ADDENDUM NO. 2 NOTICE

ADDENDUM NO. 2
NORTH GEORGETOWN ELEMENTARY SCHOOL
Georgetown, Delaware 19947

April 11, 2014

TYPICAL RATED PARTITION MARKING DETAIL - 8/A501

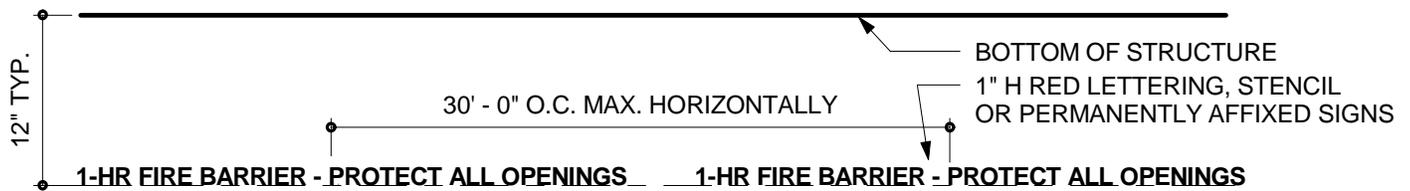
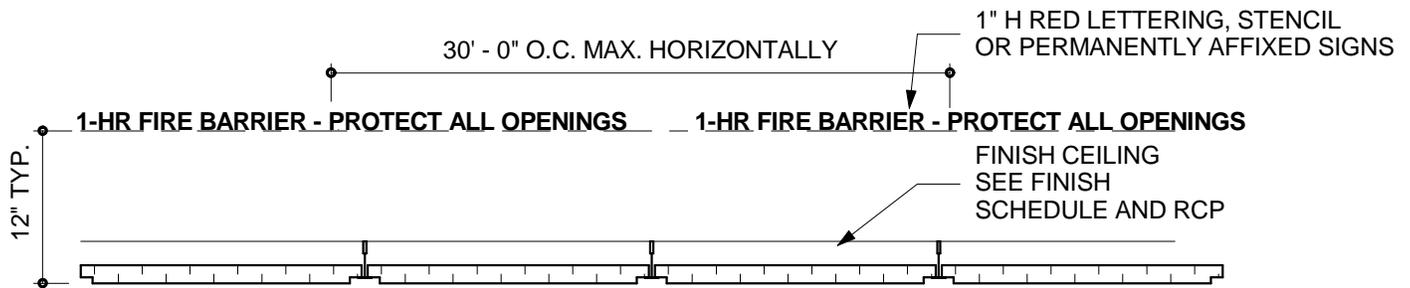
1. C-201 SITE & UTILITIES PLAN
 - a. ADD reinstalled light pole (refer to C-101) at center of new island at bus loop turnaround.
2. A100 OVERALL FIRST FLOOR PLAN AND ROOF PLAN
 - a. Detail 2, ADD devices RH-1 and RH-2, per M103, with the following note: "EQPT ON CURB – SEE MECH AND STRUCT; REFER TO DETAIL 2/A102".
 - b. ADD detail 4 per SKA-03.
3. A104 CASEWORK AND FINISH PLAN, FINISH SCHEDULE, AND FINISH LEGEND
 - a. Finish Schedule, REVISE floor finish at IDF 117A from CPT to VCT.
 - b. Finish Schedule Legend, REVISE spec reference for CPT-1 from 096816 to 096813.
4. A501 WALL TYPES AND MISCELLANEOUS DETAILS
 - a. ADD detail 8 "Typical Rated Partition Marking Detail", per SKA-01.

DOOR SCHEDULE - A601
PROJECT NO.: 2013157.00
DATE: APRIL 9, 2014
SCALE:
DRAWN BY: JML

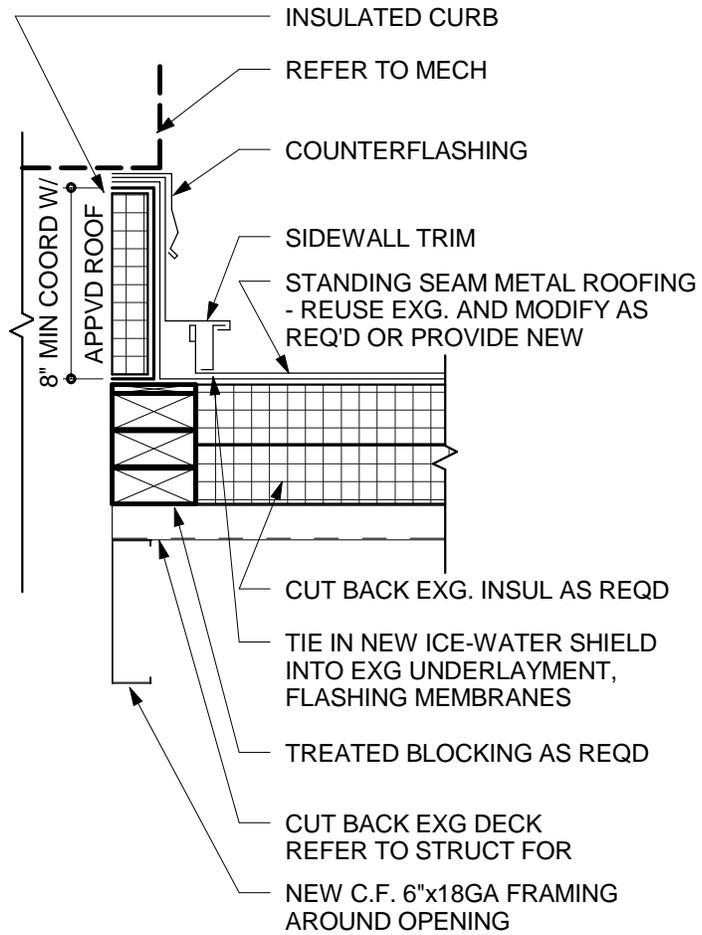
5. A601 DOOR SCHEDULE
 - a. REPLACE door schedule with attached, per SKA-02
